To: T10 Technical Committee
From: Rob Elliott, HP (elliott@hp.com)
Date: 27 August 2005
Subject: 05-306r0 SAS-2 STP connection time limits and STP/SMP I_T nexus loss

Revision 0 (27 August 2005) First revision

Figure 2 — PL_PM (port layer phy manager) state machine (part 1)

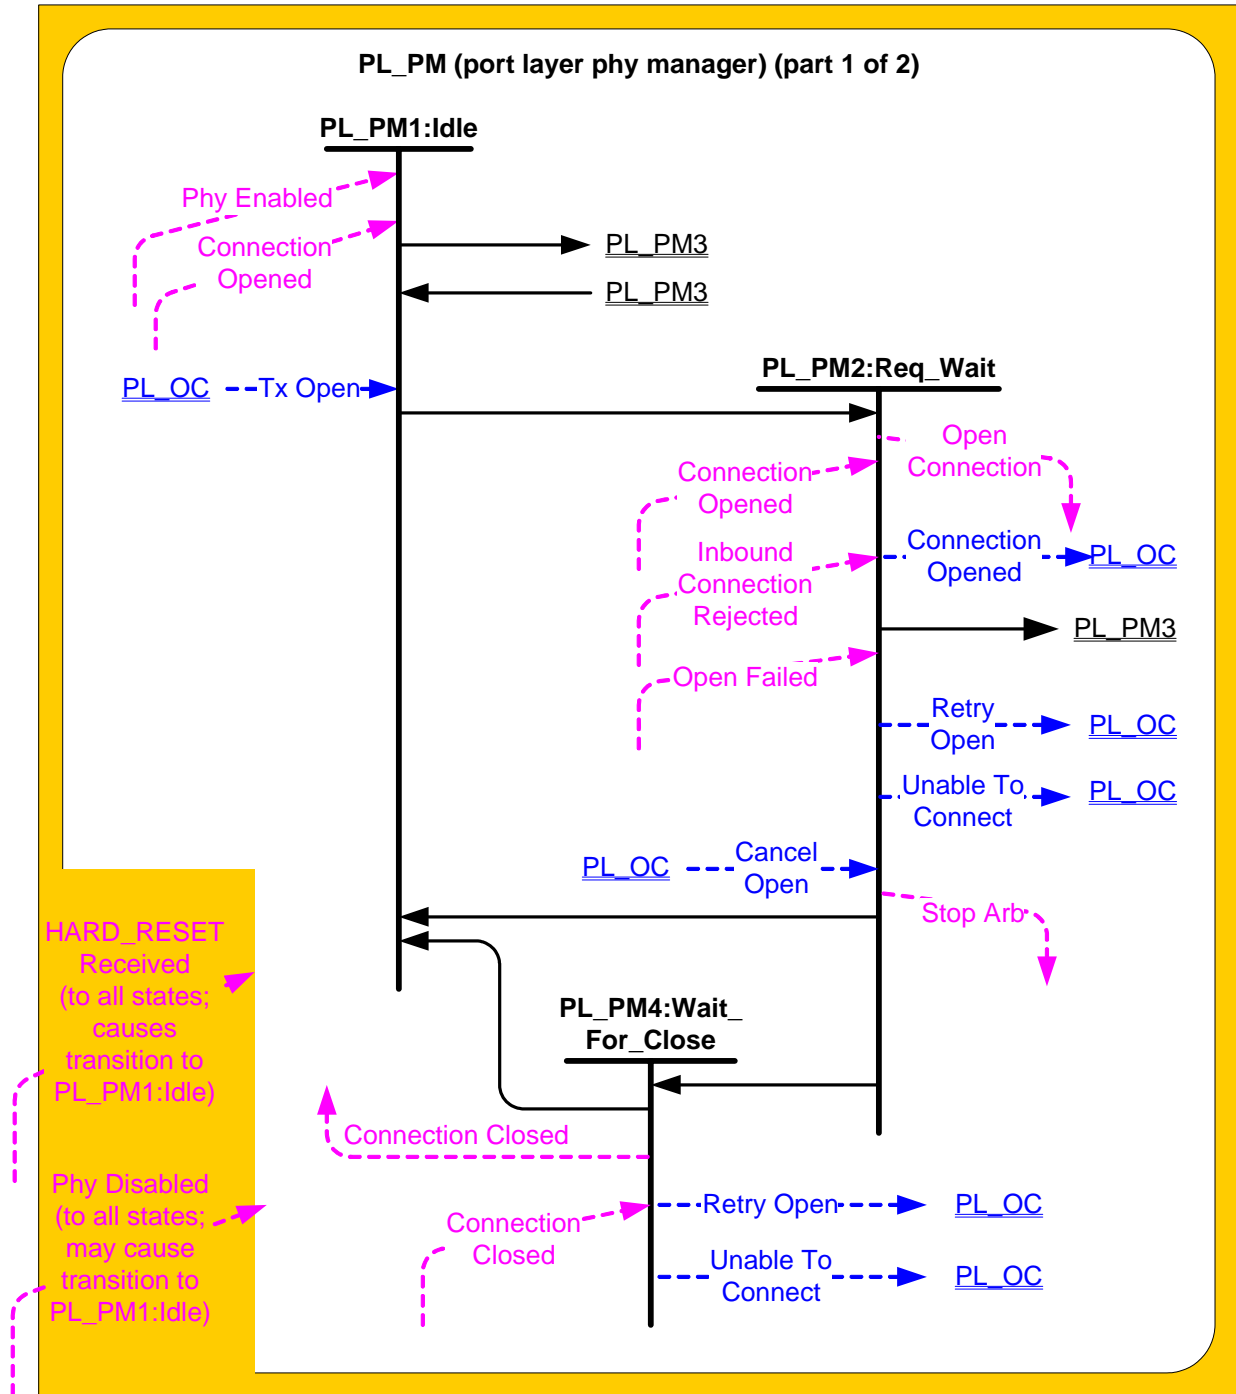
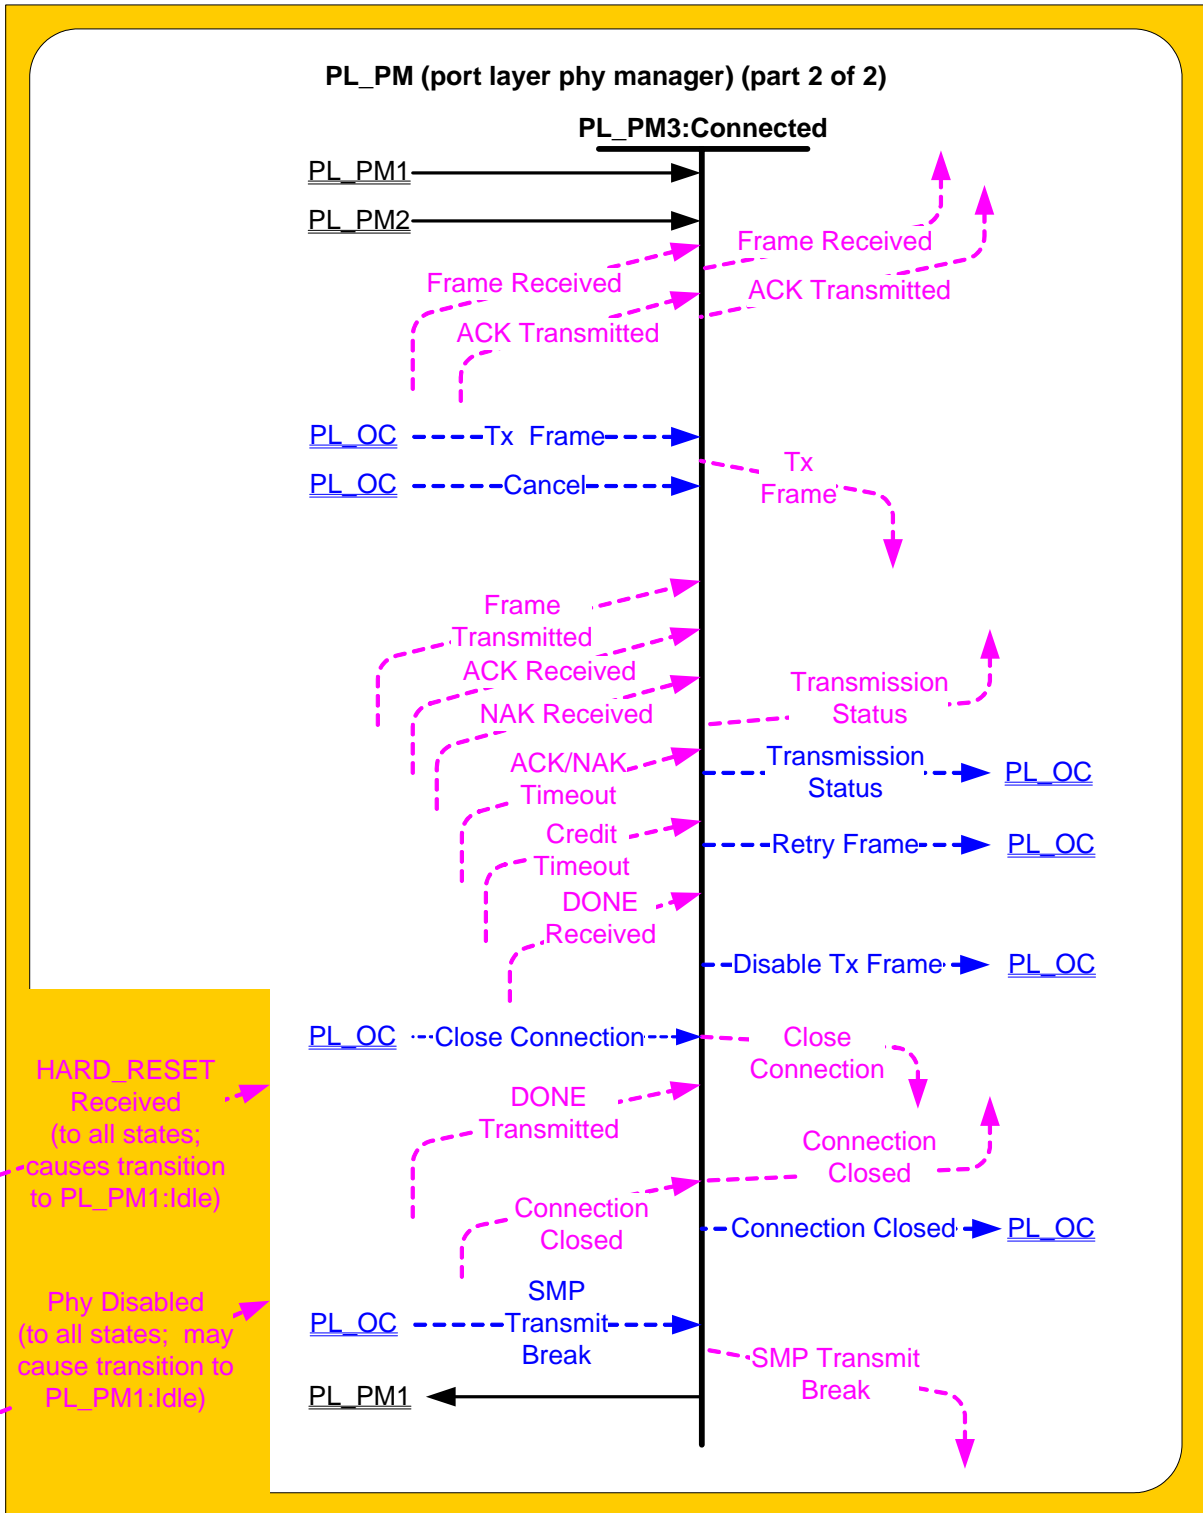
[Editor's Note 12: SMP Transmit Break is in the figure but not in the text](#)
